## ADDENDUM NO. 1

PROJECT: PELHAM RENAMING EFFORT  
ANNISTON, ALABAMA

23-1299  
 PELHAM RENAMING EFFORT  
 FT. McCLELLAN, ALABAMA  
 SEPTEMBER 18, 2023  
 SD-1 (REF. DWG. BI.A/A1.1)

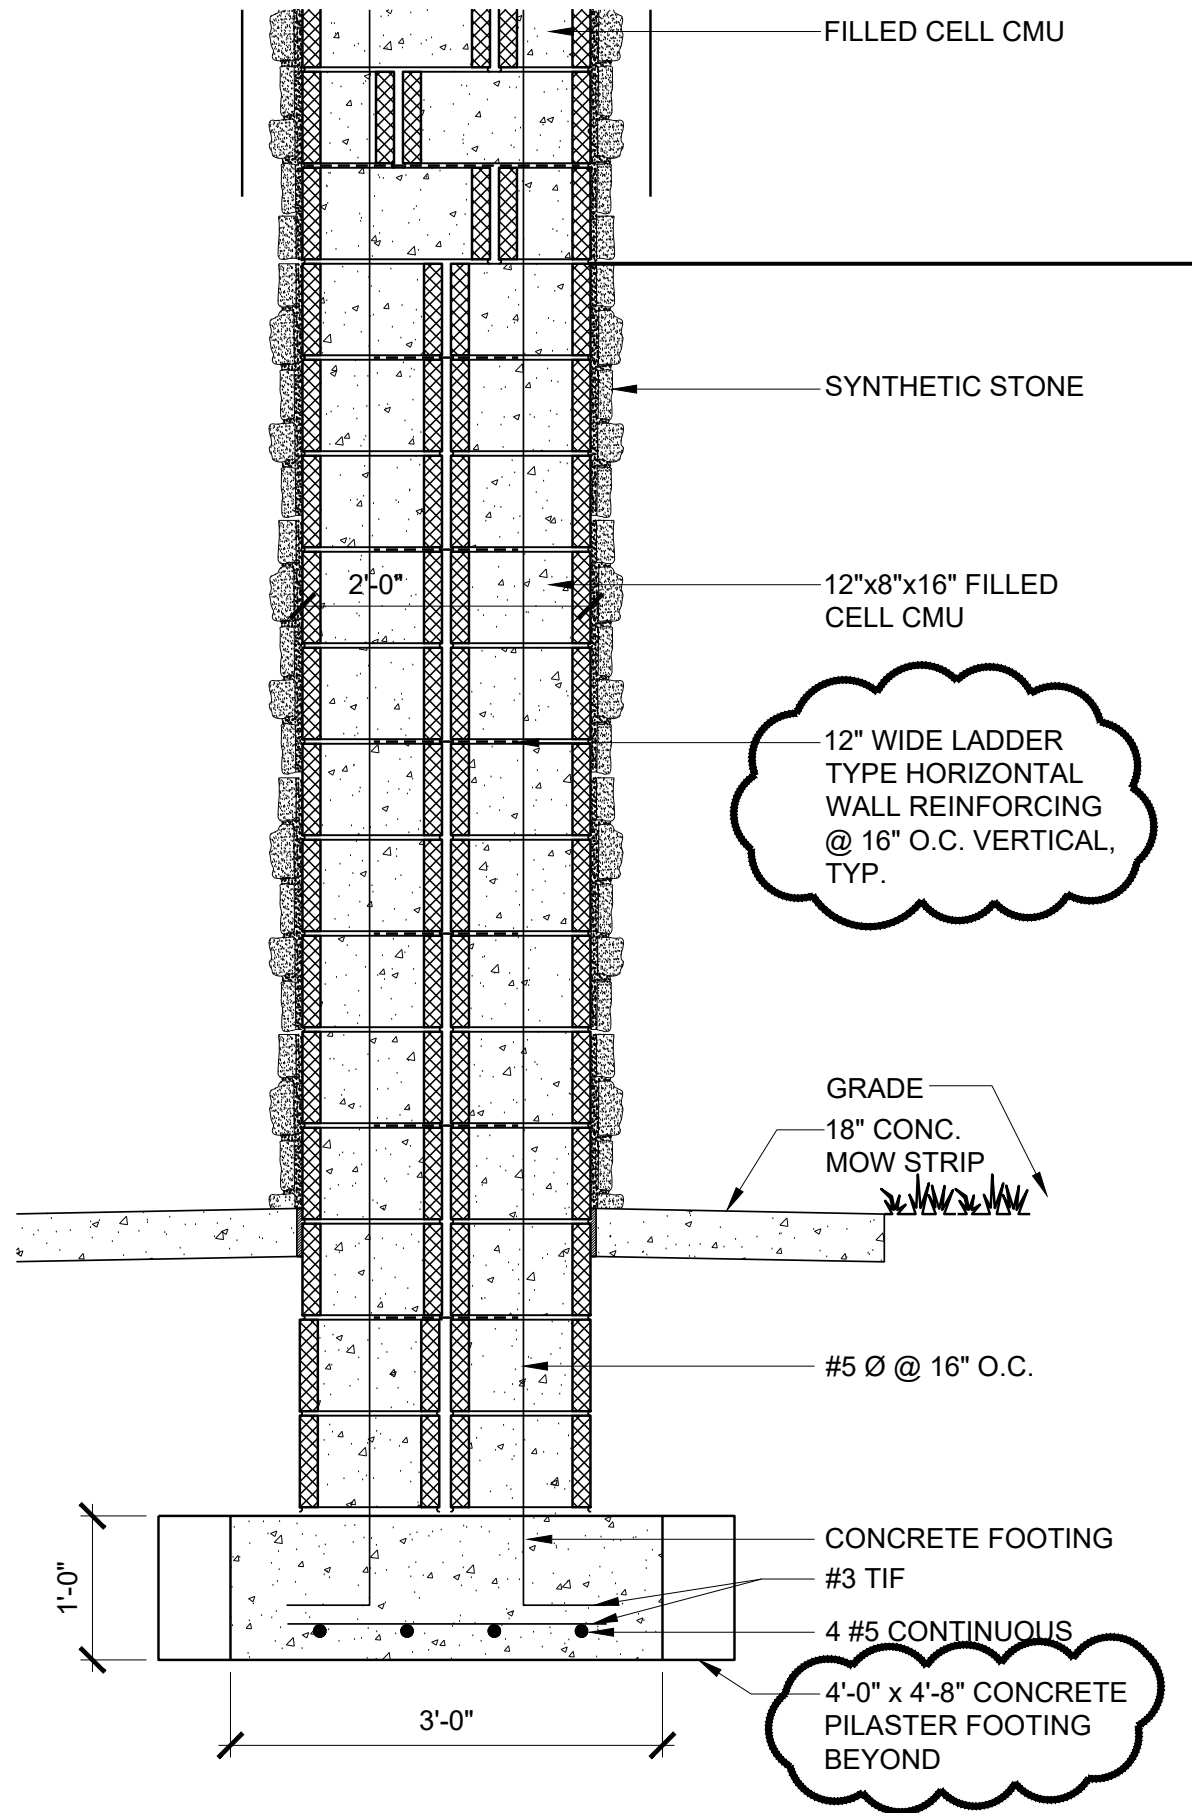
4. Refer to Plans, Sheet BI.A/A1.1 & SD-1 thru SD -5:
  - A. Clarification and Details Provided to Revise the Footing Under the Monumental Sign Pilaster and the Synthetic Stone Cap, Refer to Details for Direction

## PILASTER DETAIL

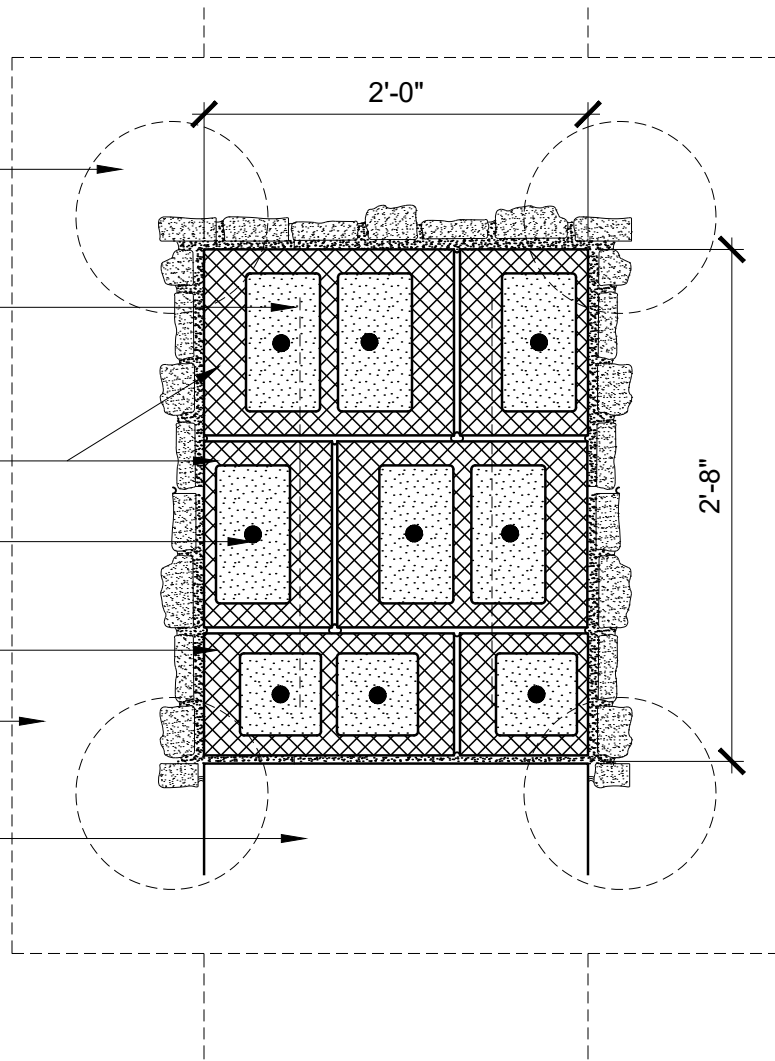
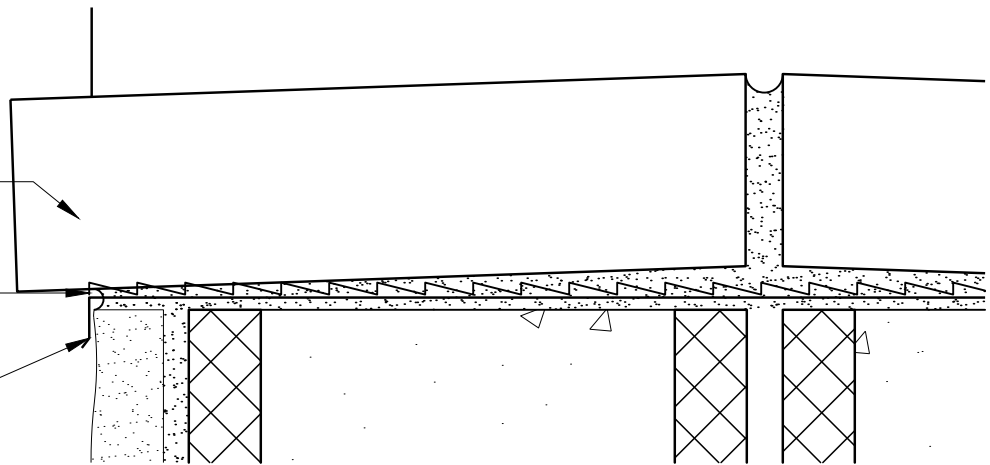
7. Refer to Plans Section 5/A1.1, Bid Item A:
  - A. Note: Synthetic Stone Cap will be 4" thick minimum and will be installed with positive slope to drain to each side. Slope shall be 2% minimum from center to wall edge.
